Chorka Apparels Ltd. (Extension)

25 January 2024

2. Observations

Observation-2: Inadequate number of concrete cylinder test report (CS Building)

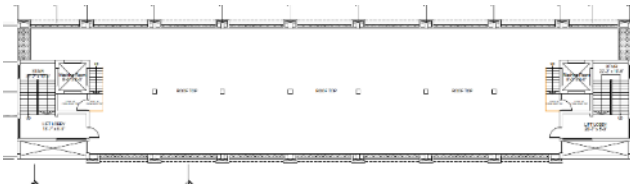
Description: Design concrete compressive strength (f'_c) is considered as 3500 psi (24.13 MPa). Adequate number of concrete cylinder test reports were not available onsite as per BNBC. The building engineer is required to take adequate number of concrete core sample to justify the design strength.
